Re: Fire Station #5 Plan Review Conditions from 12/07/2022

Building Plan Review Reviewed By: Joe Frogge Rejected

Reference: Lee's Summit Fire Station 4 Storm Shelter Peer Review

11.21.2022

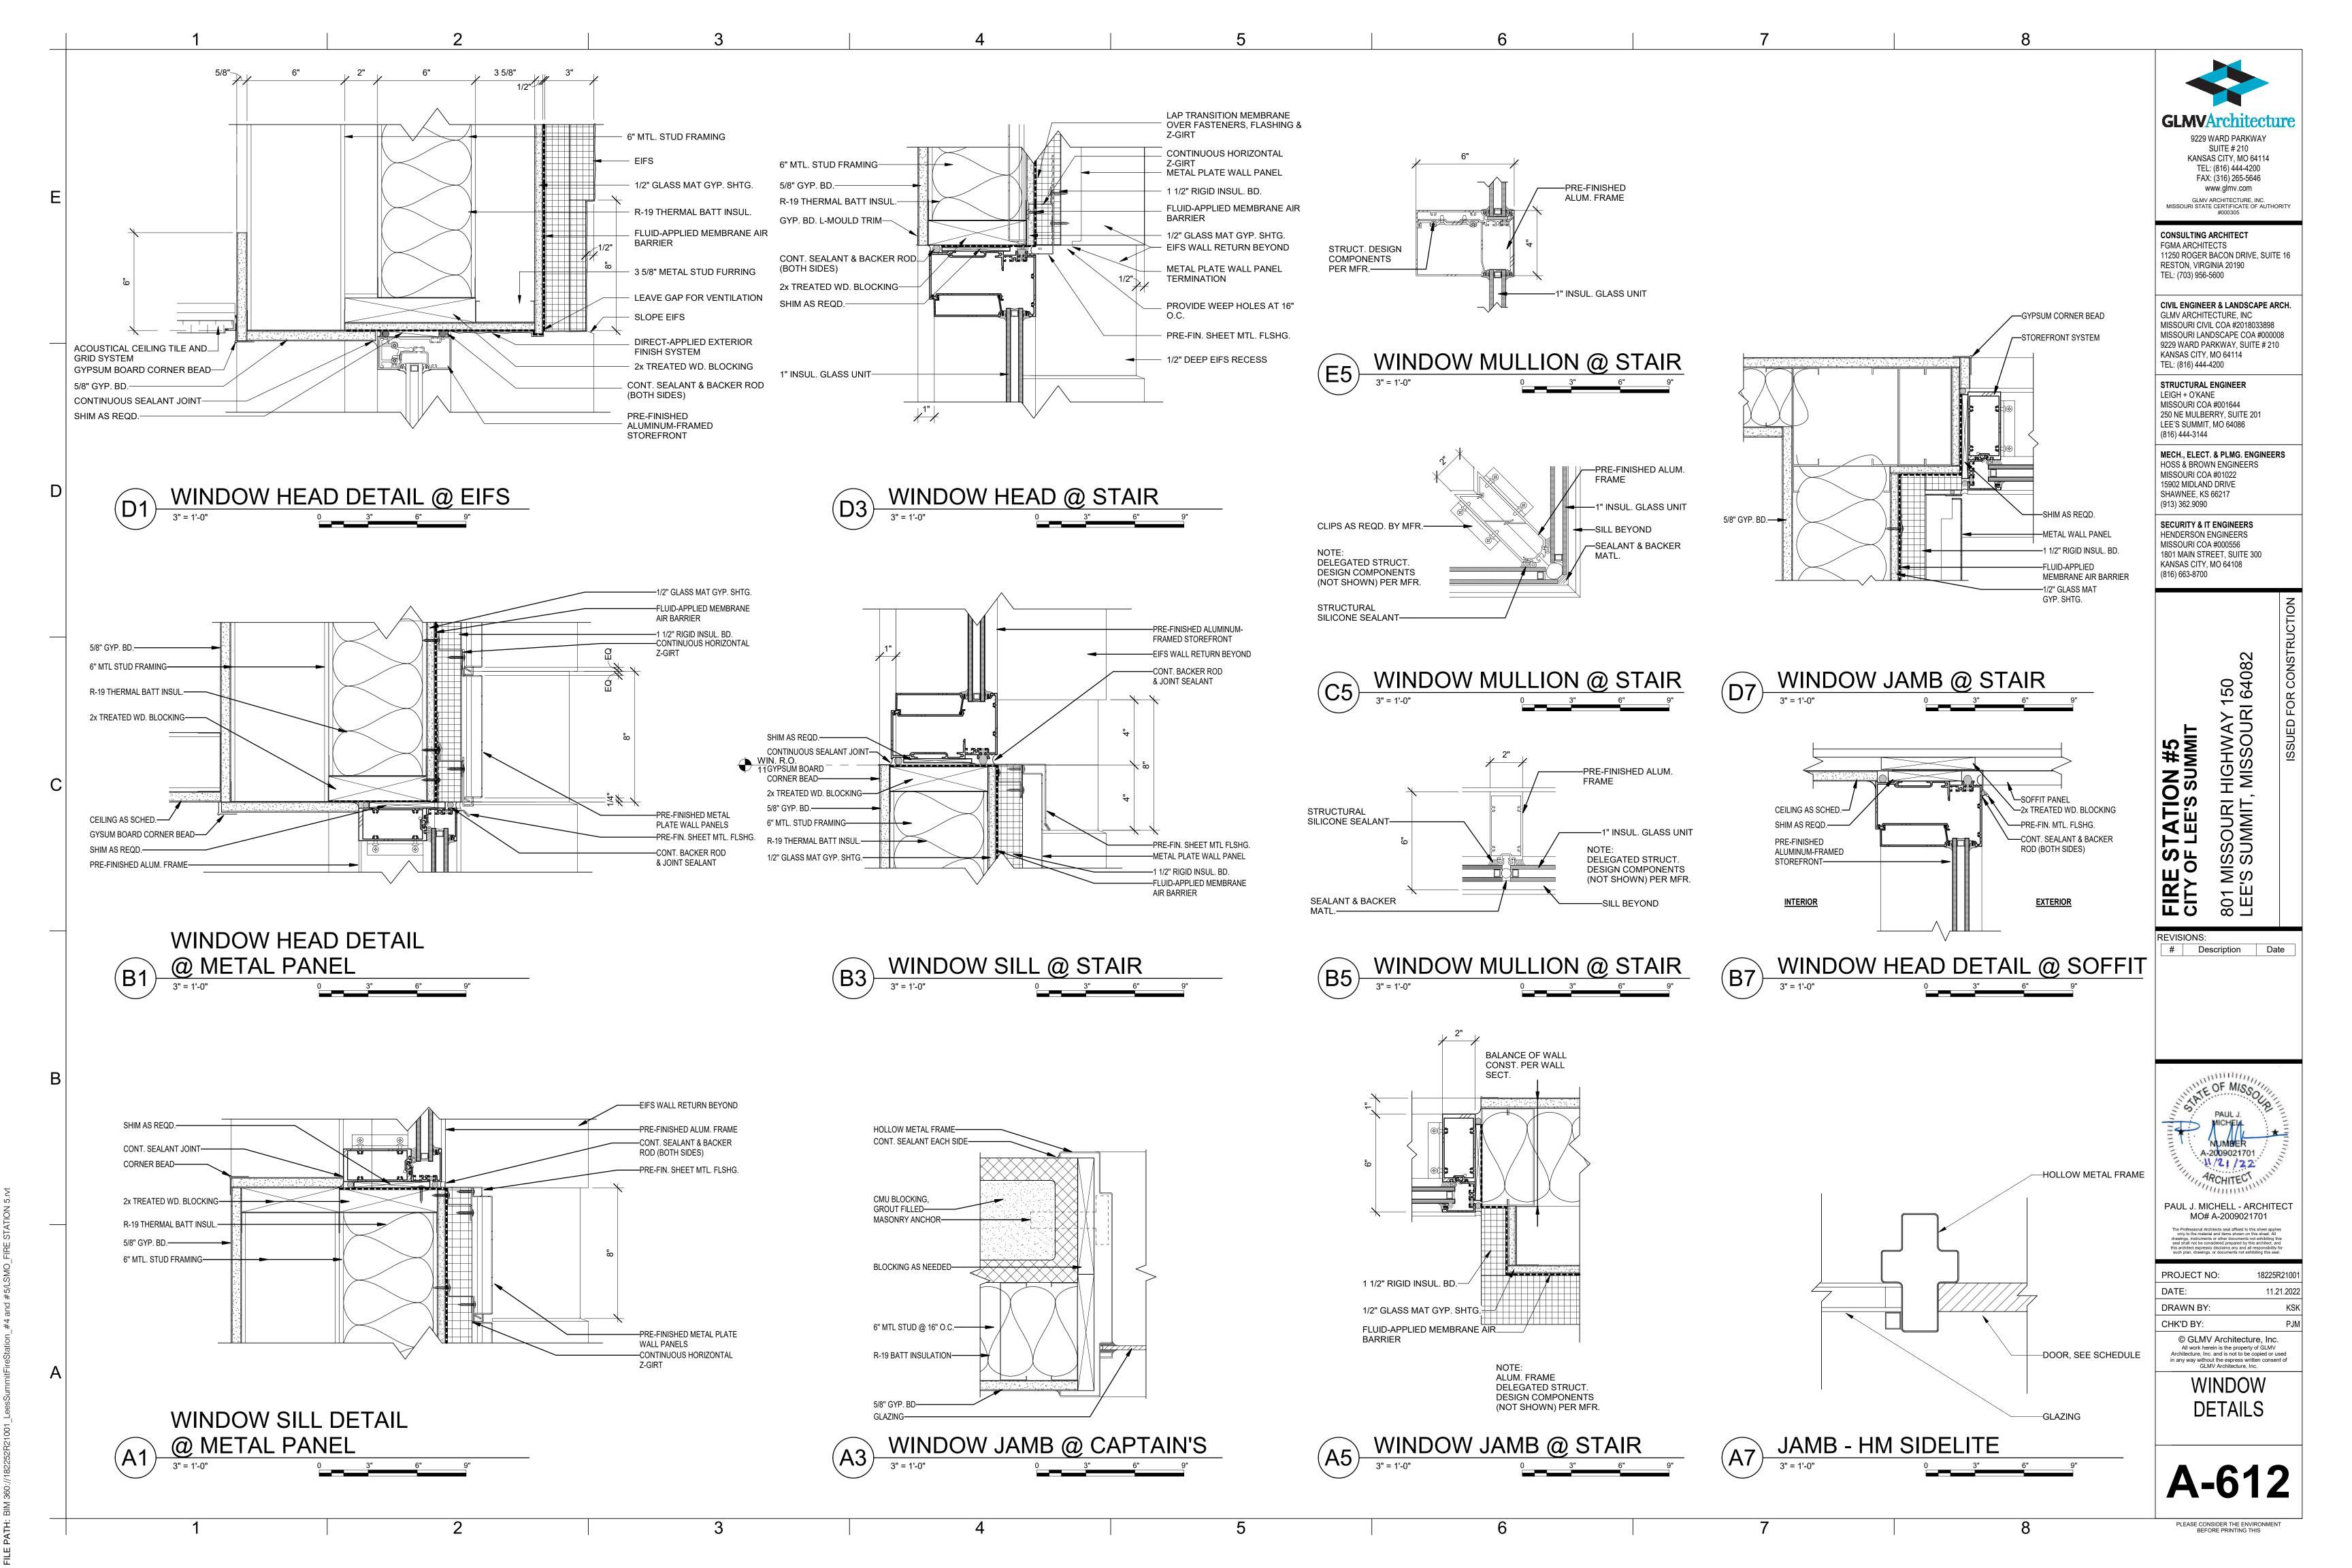
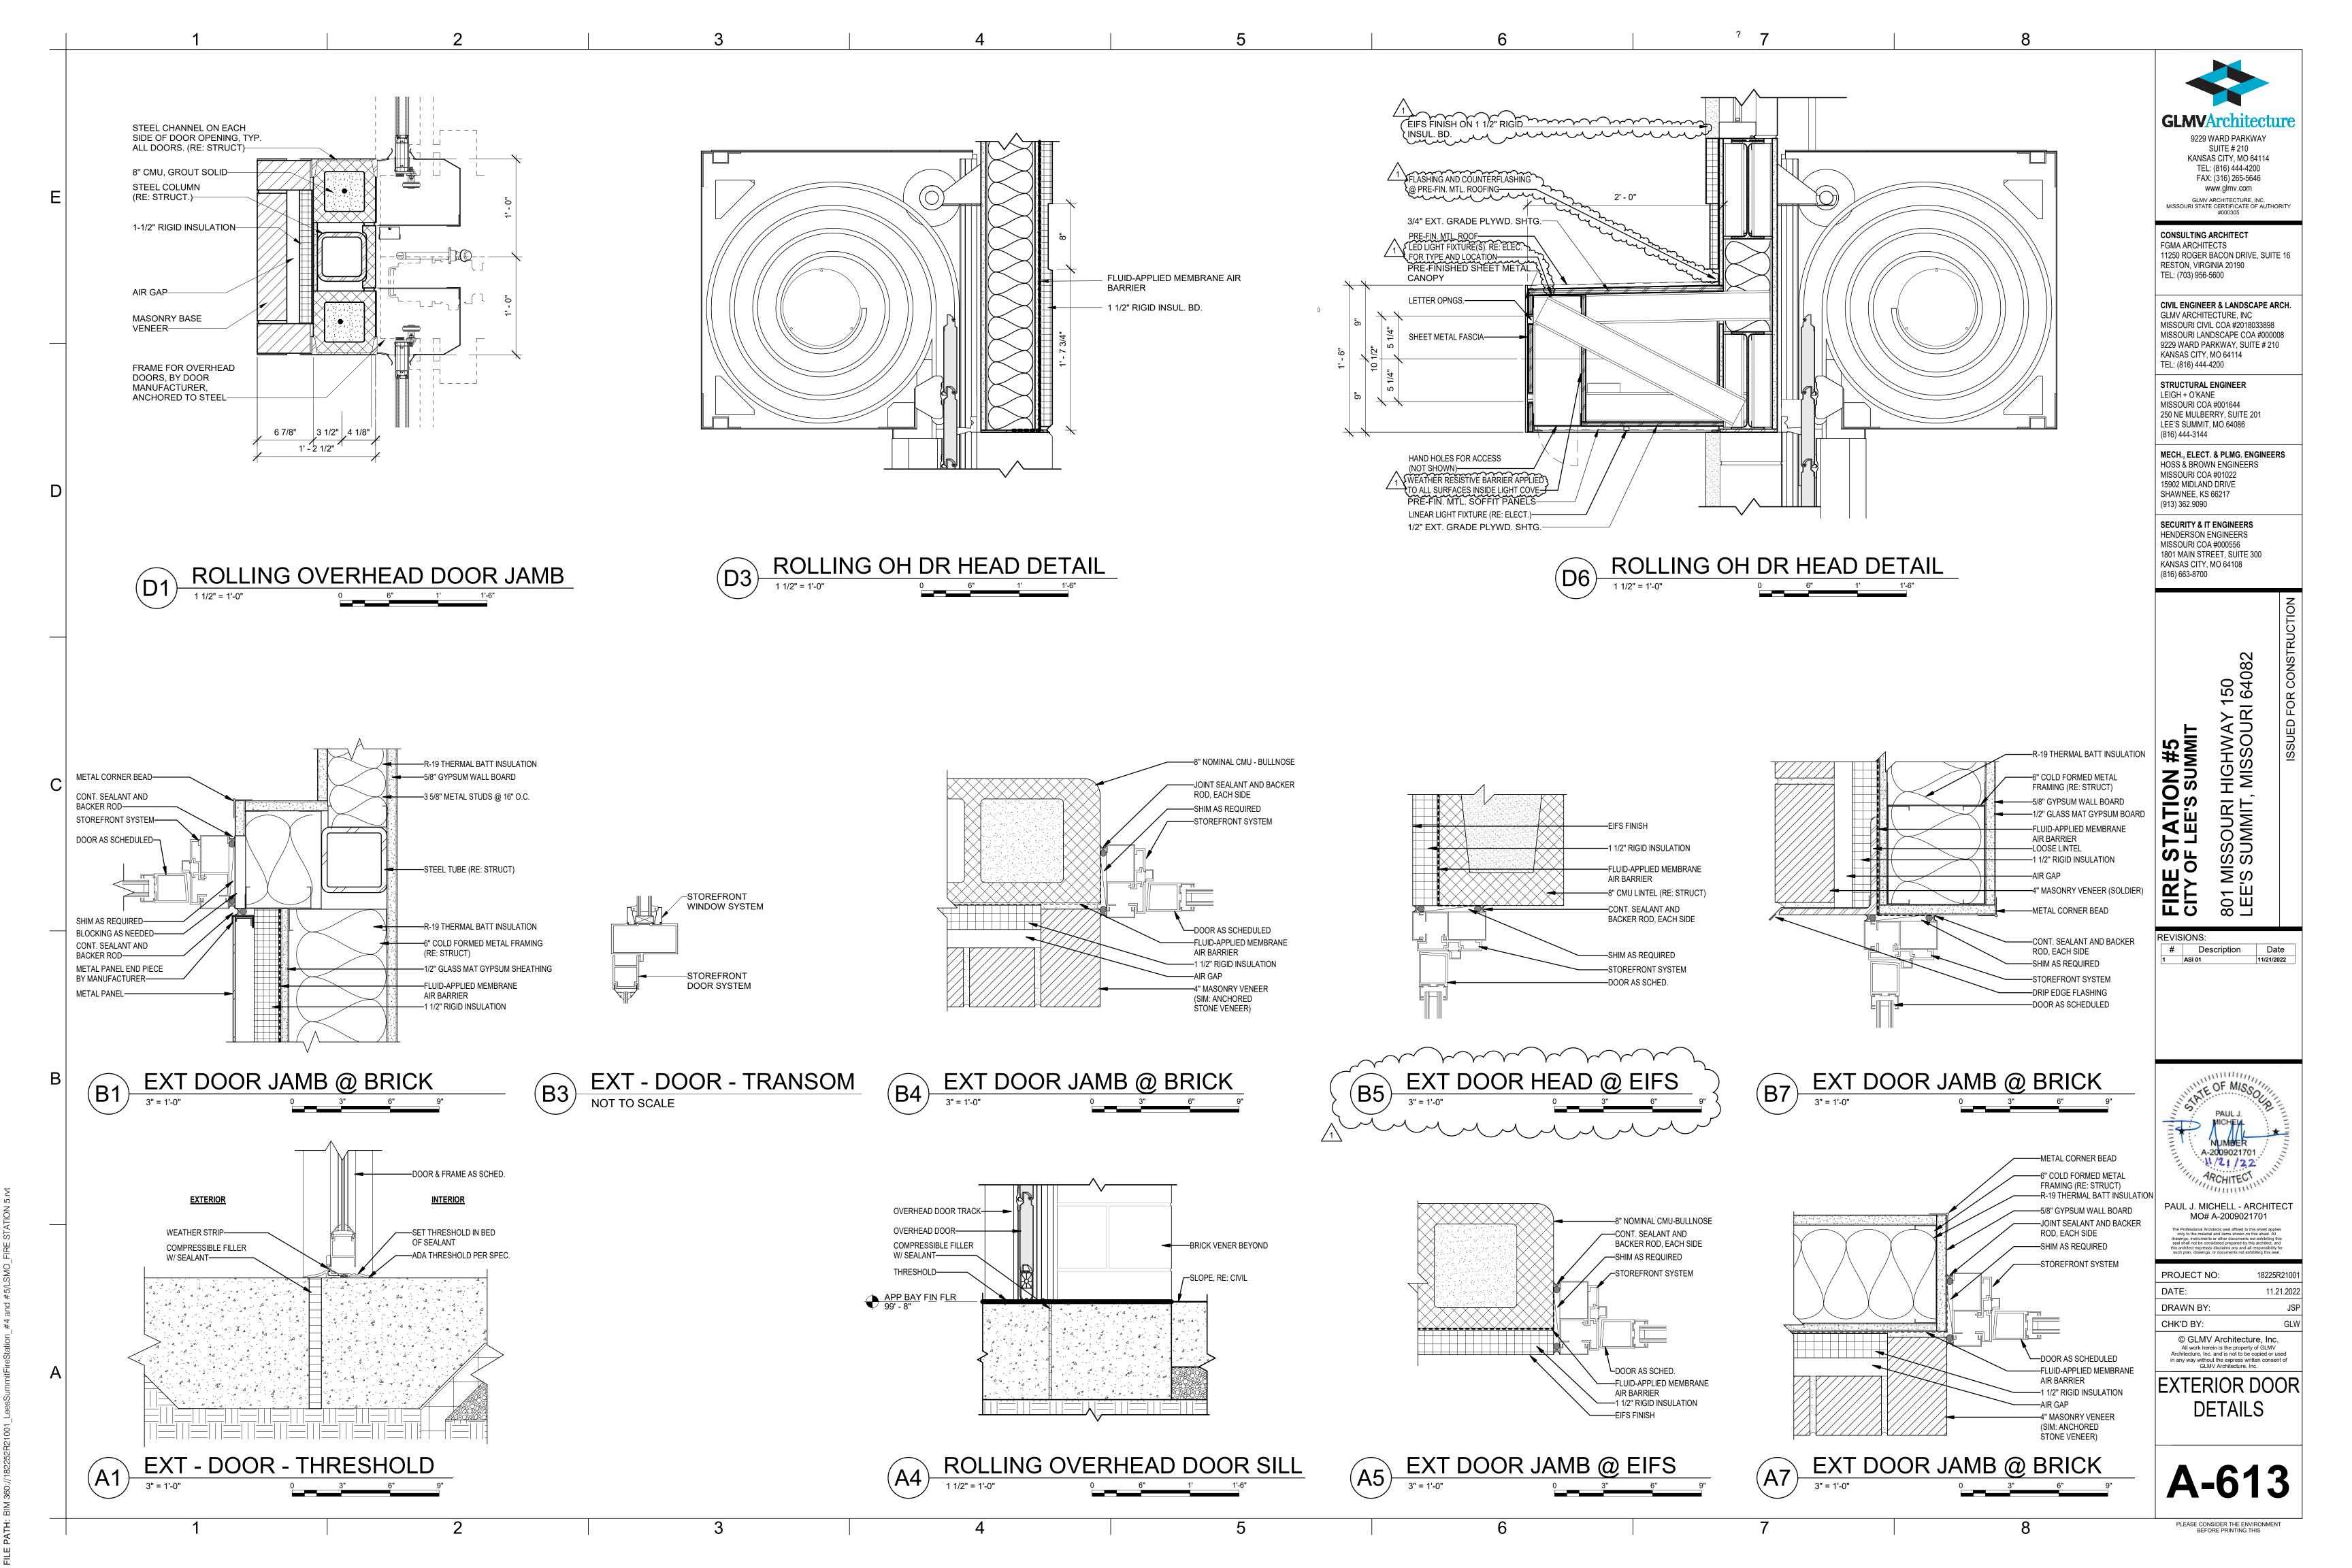
7. 2018 IBC 706.1 General. Fire walls shall be constructed in accordance with Section 706.2 through 706.11. The extent and location of such fire walls shall provide a complete separation. Where a fire wall also separates occupancies that are required to be separated by a fire barrier wall, the most restrictive requirements of each separation shall apply.

Action required: Provide complete UL details that include nail/screw patterns. 12/5/22 - Complete detail for UL 419 required

Responses: 12/23/2022 UL details, including fastener patterns for track, framing and sheathing are shown on sheet A-602 (see attached drawing sheet)
